Class Rule Changes

International Nacra15 Class Association

Effective date: 2025 December 16

C.11.3 (b) IDENTIFICATION

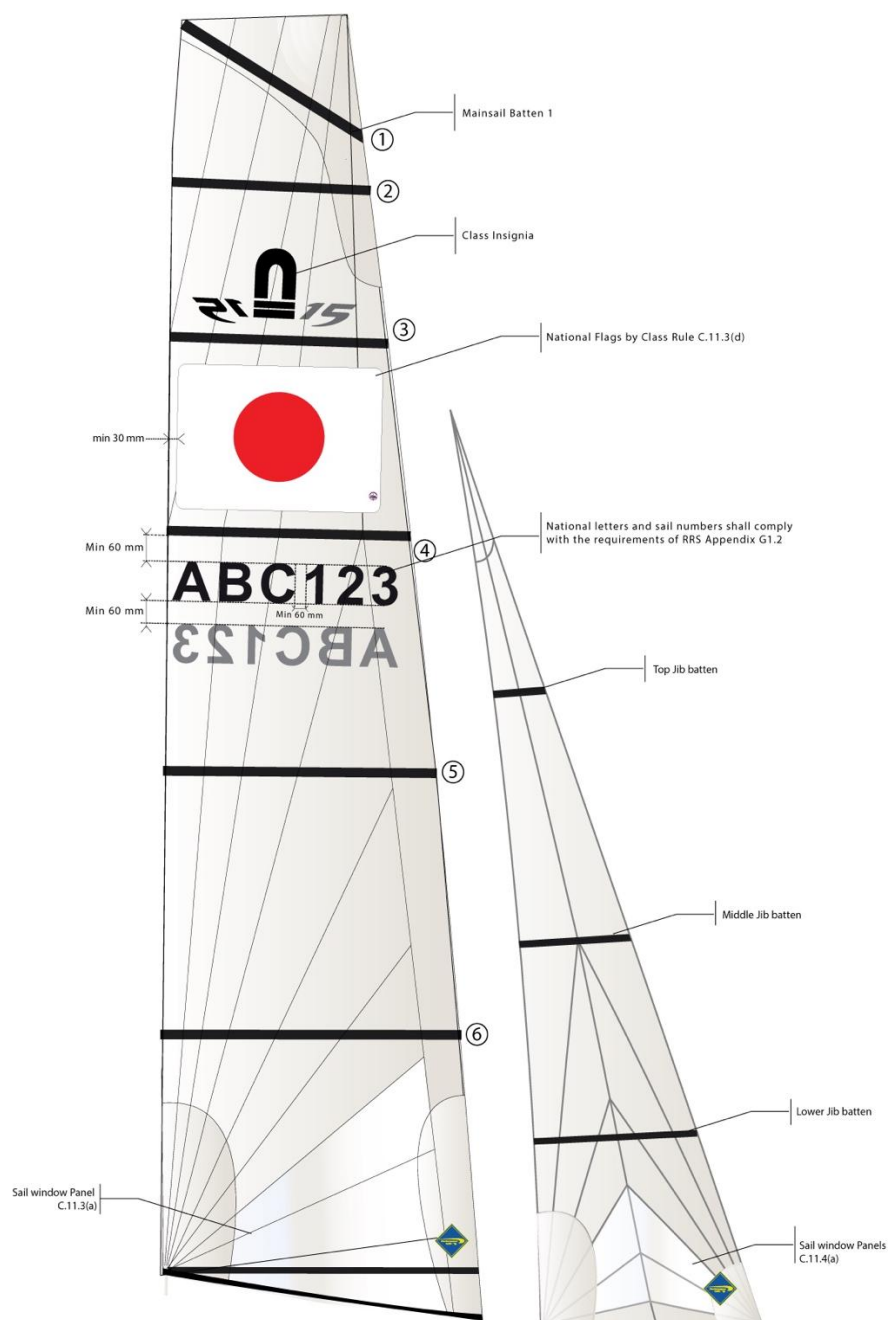
C.11.3 MAINSAIL

Old:

(b) IDENTIFICATION

Sail numbers shall be any of the following:

Amend to read

The national letters and numbers shall comply with the RRS Appendix G except where specified otherwise in the diagram below.

In the International Nacra 15 Class World Championship and Continental Championships, the sail numbers shall be:
